# **MONITORING YEAR 1 ANNUAL REPORT**

## **BANNER FARM MITIGATION SITE**

RE: **Banner Farm Draft MY1 Report Review  
French Broad River Basin – CU# 06010105  
Henderson County  
DMS Project ID No. 100062  
Contract # 7530**

Wildlands Engineering, Inc. (WEI) has reviewed the Division of Mitigation Services (DMS) comments from the Draft MY1 Monitoring report for the Banner Farm Mitigation Site provided in bold type below and offers the following responses in italics.

Henderson County, NC

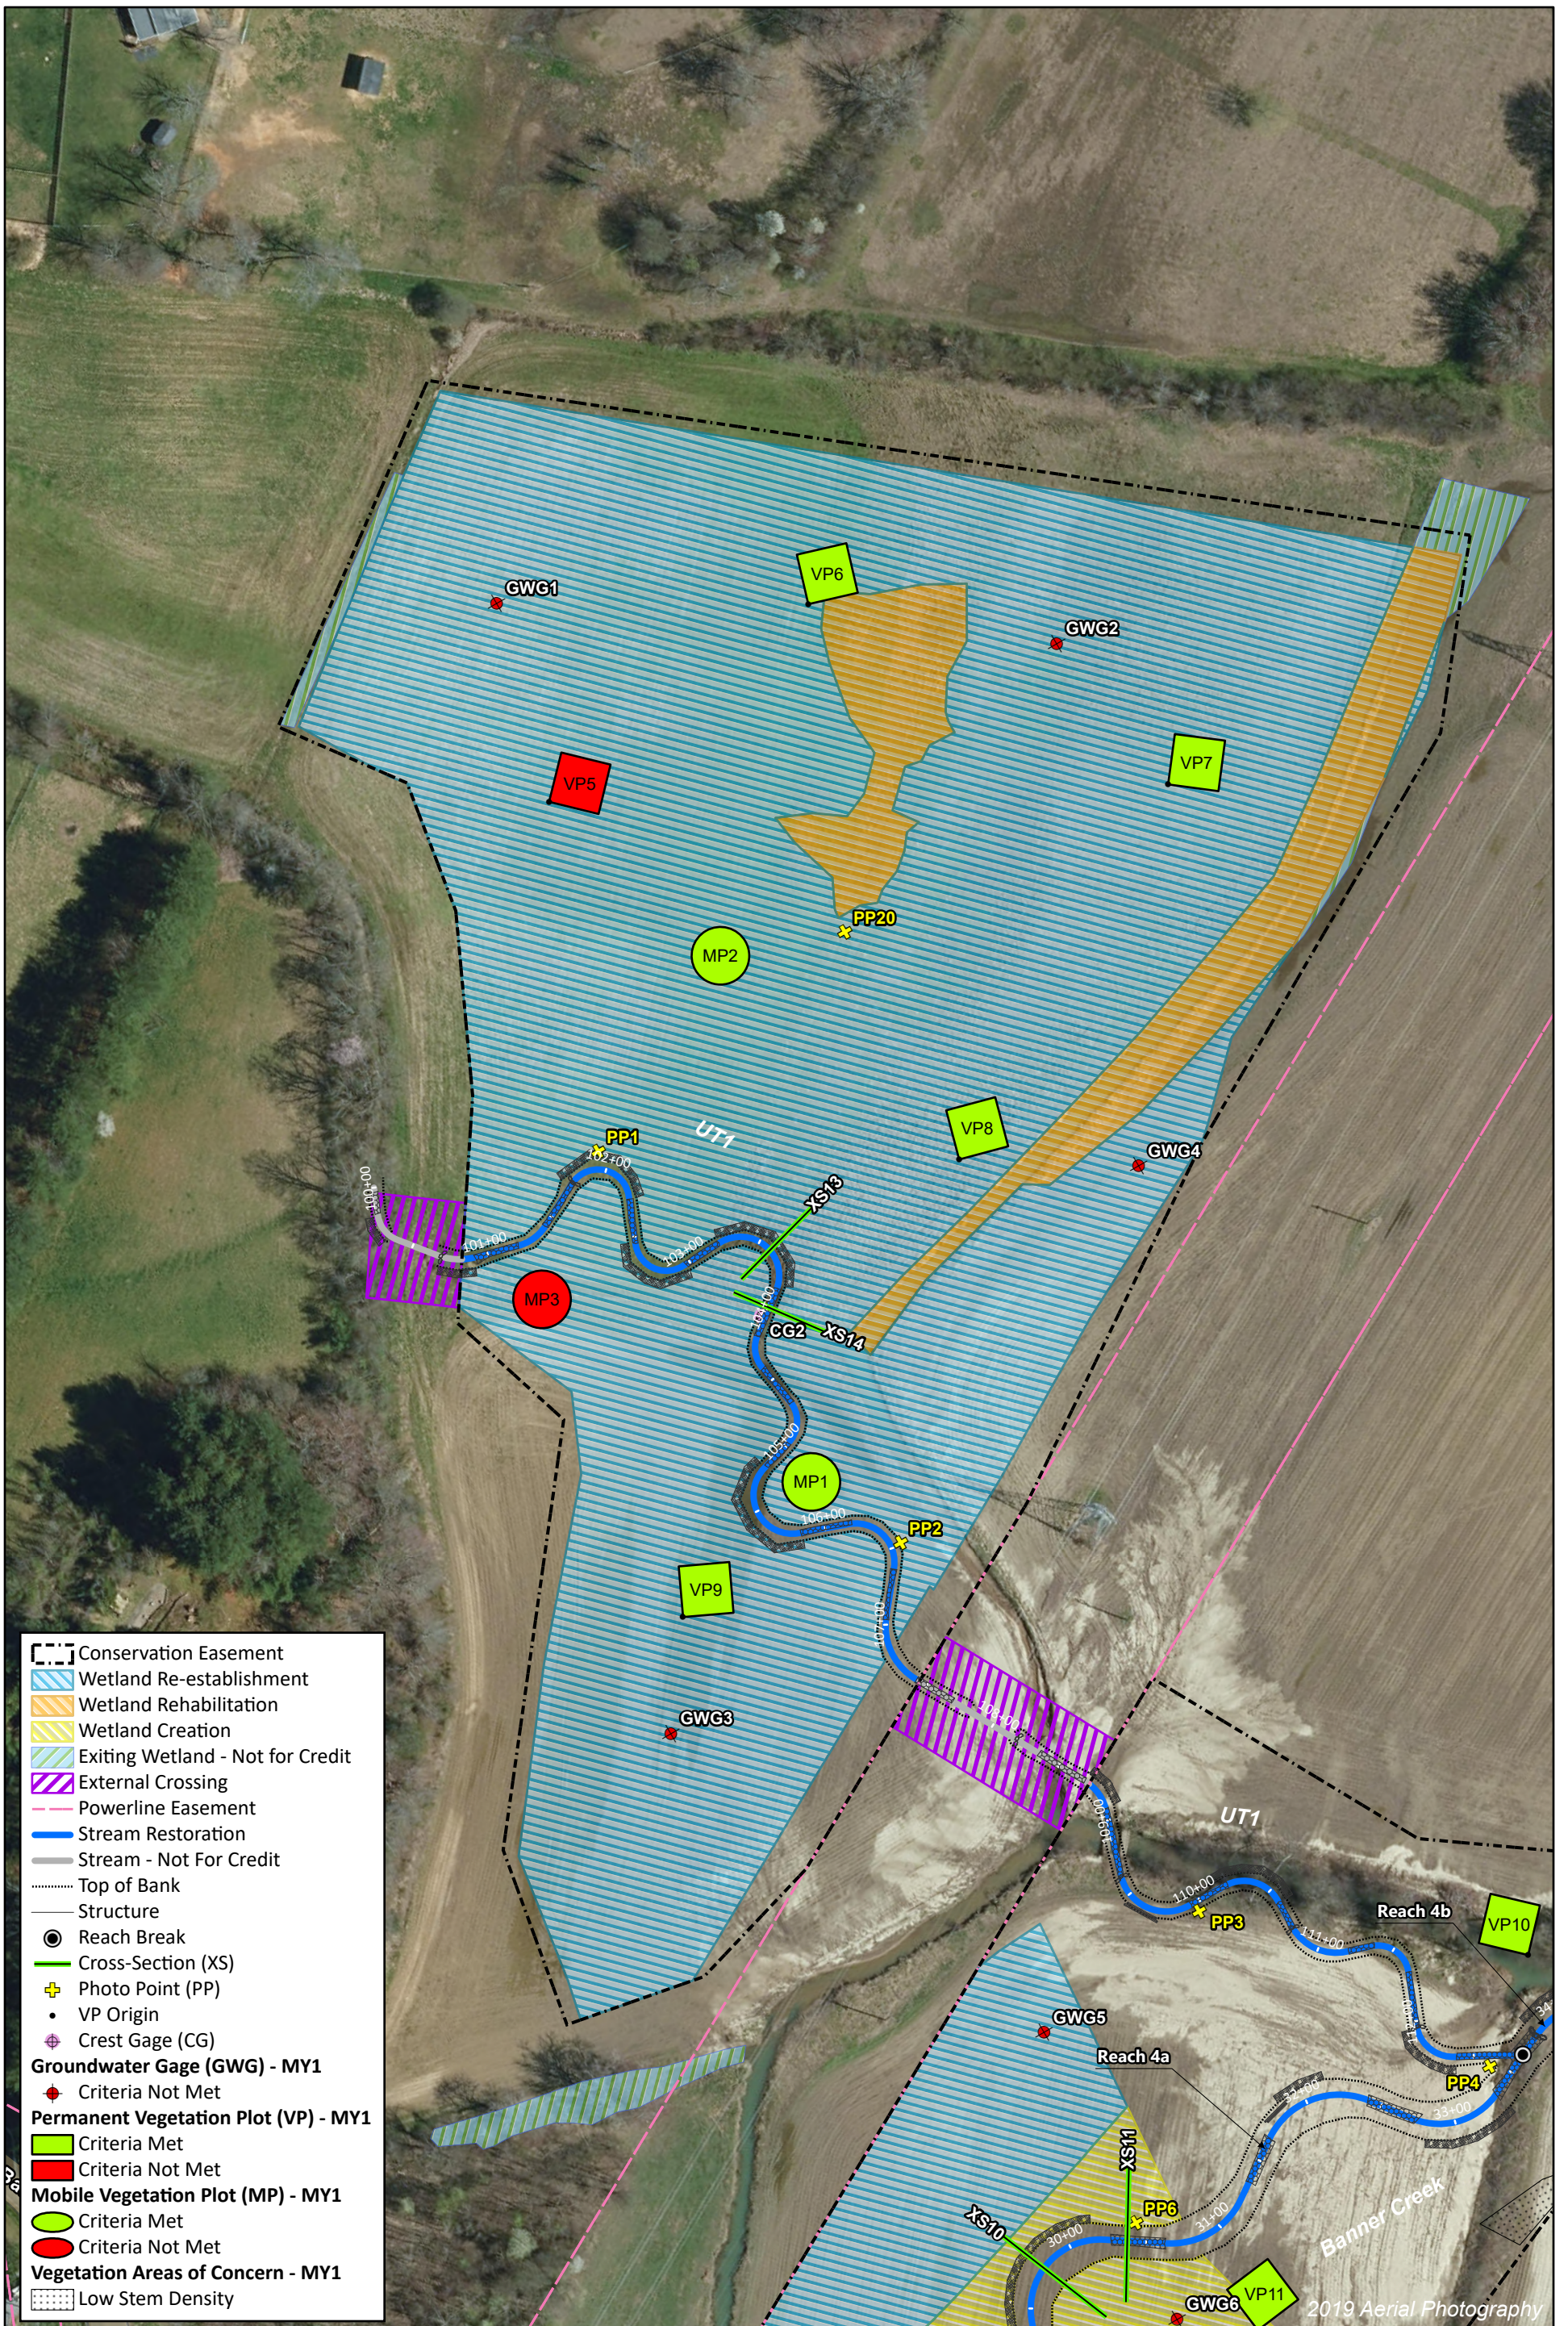
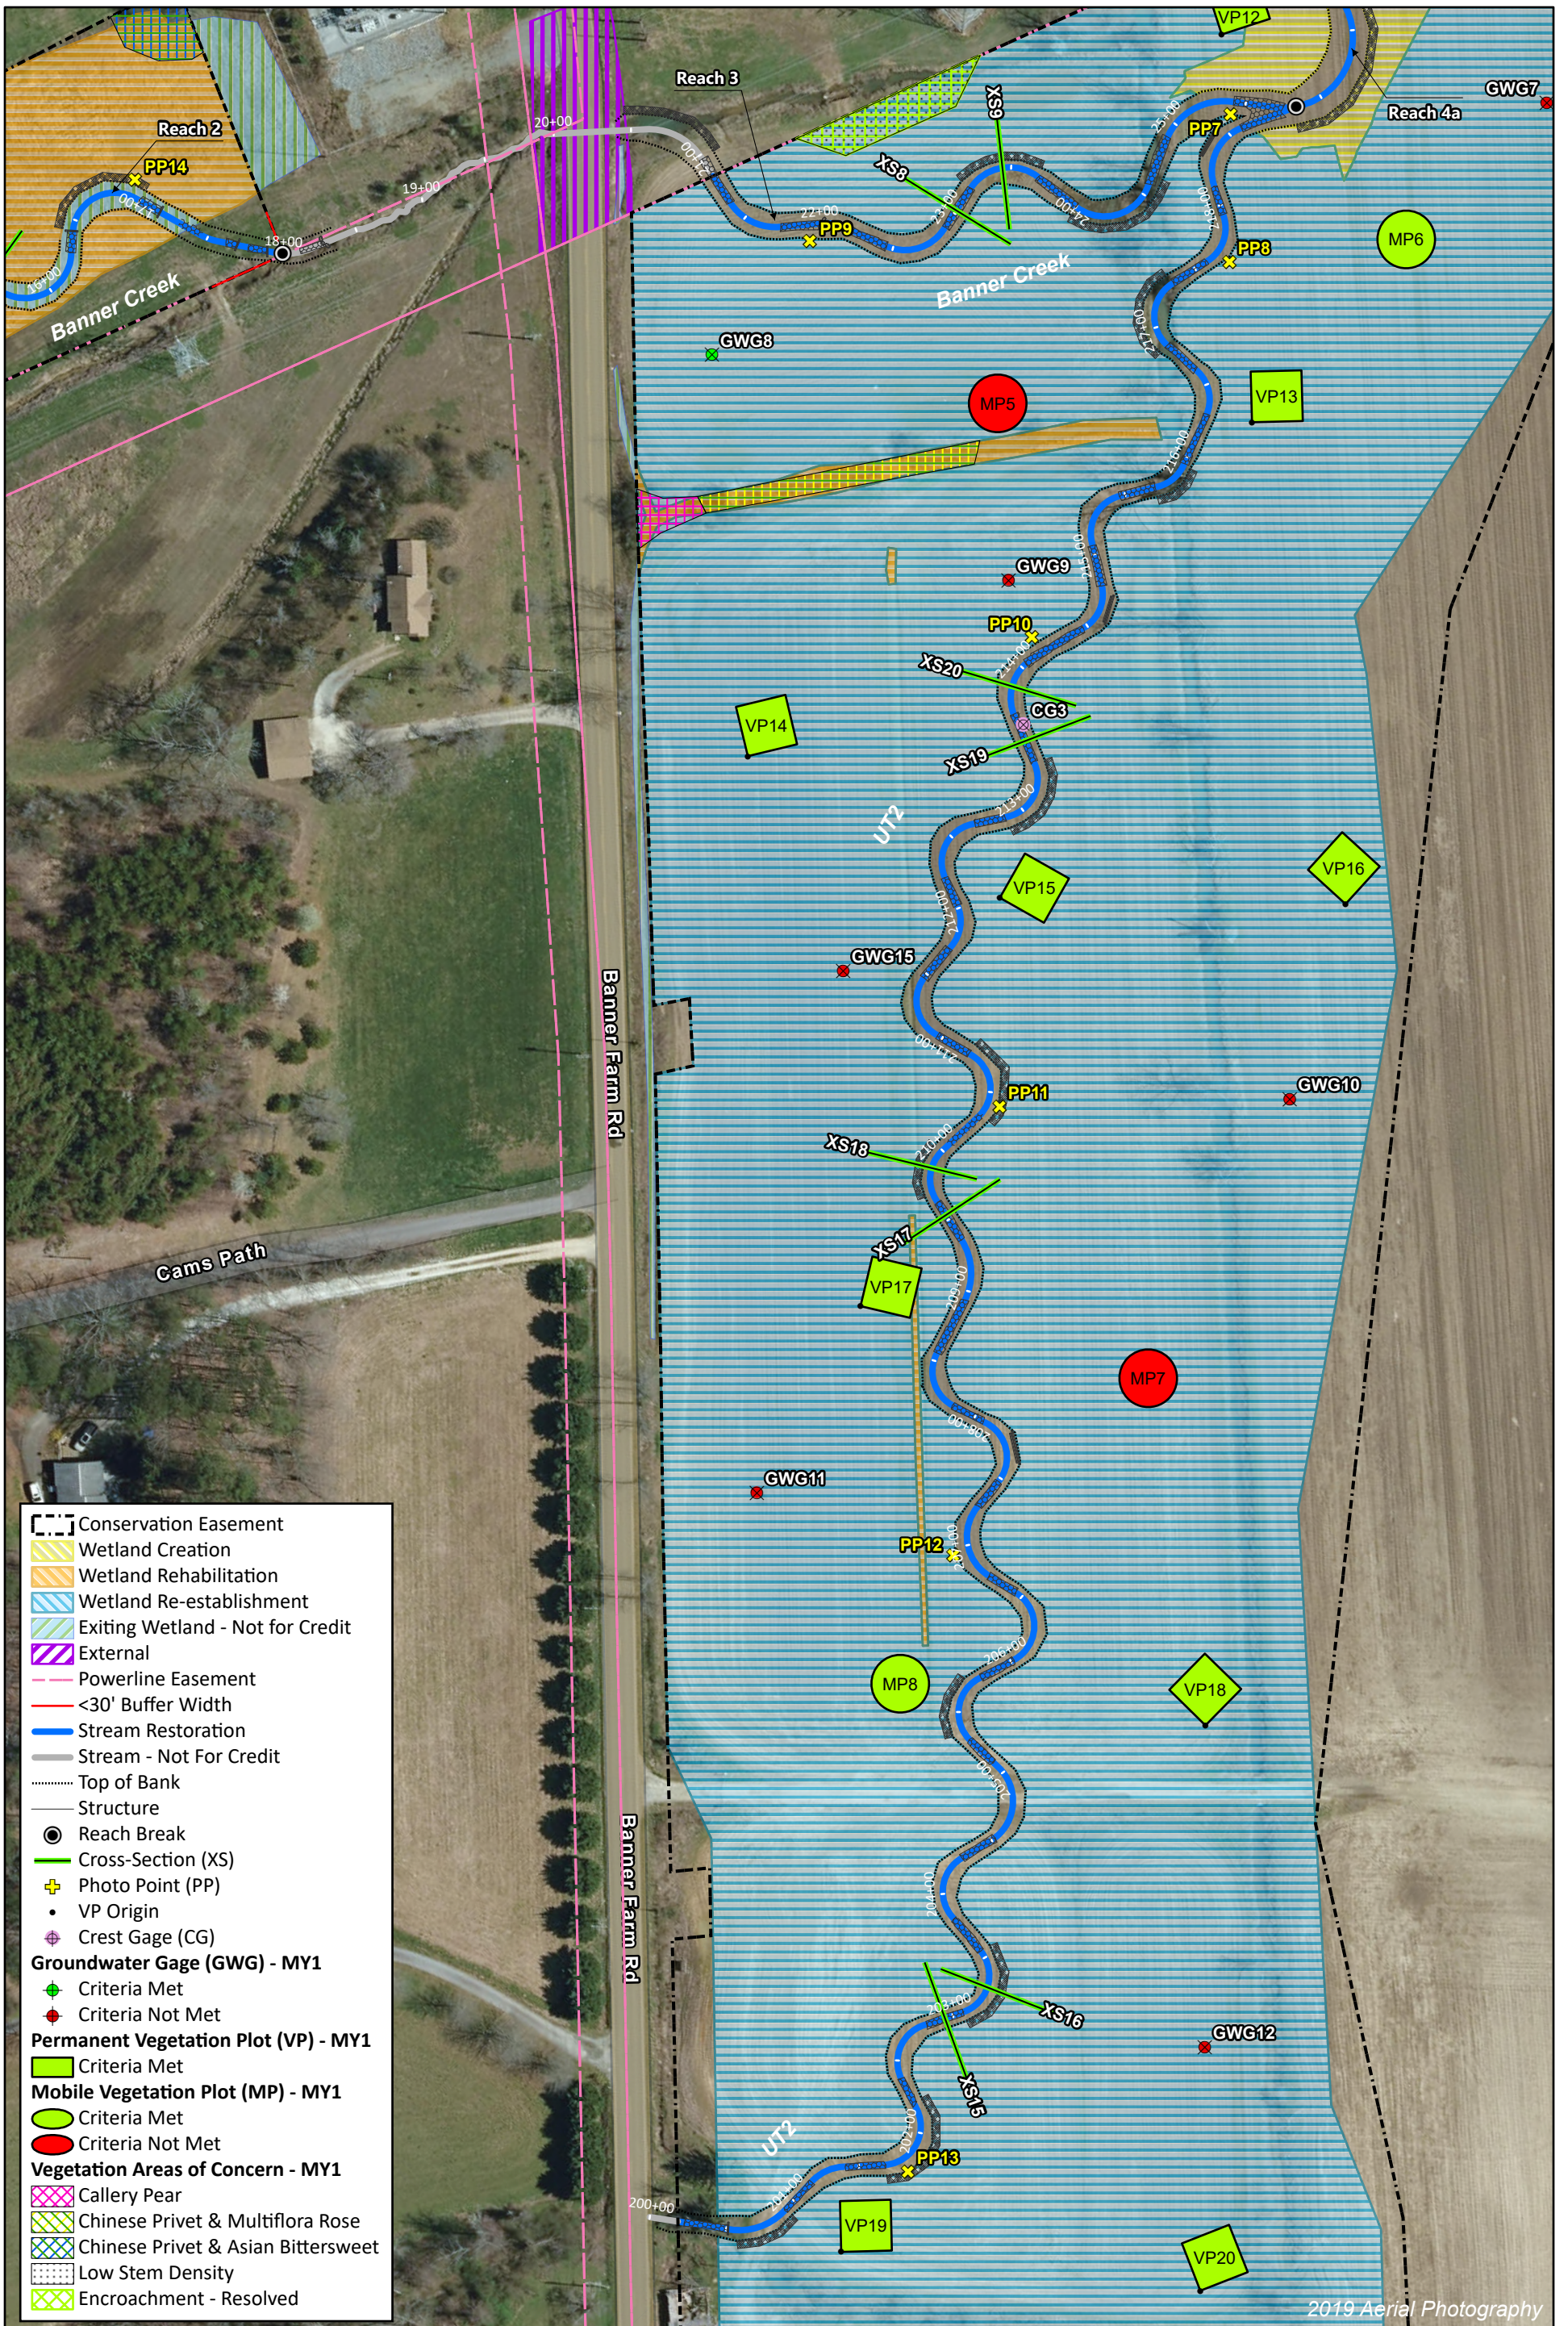
**Easement Encroachments: Discussion on easement encroachments is unclear. Two encroachments are discussed in section 2.5.1 Vegetation, and additional encroachments are discussed in section 2.5.3 Conservation Easement. The CCPV shows two encroachments. The first is on Banner Creek R2 (Fig 1a) and a second encroachment near the beginning of UT2 (Fig 1e). The two encroachments mentioned in 2.5.1 are not shown on the CCPV as encroachments, but they are shown as low stem density. Recommend showing all encroachments on CCPV and discussing in more detail in section 2.5.3 regarding location and description of each encroachment. A table or list would be helpful.**

*Wildlands Response: Discussion of the specific easement encroachment locations along with a summary table have been added to section 2.5.3. The resolved and unresolved encroachments that are discussed in the report have been added to the CCPV figures.*
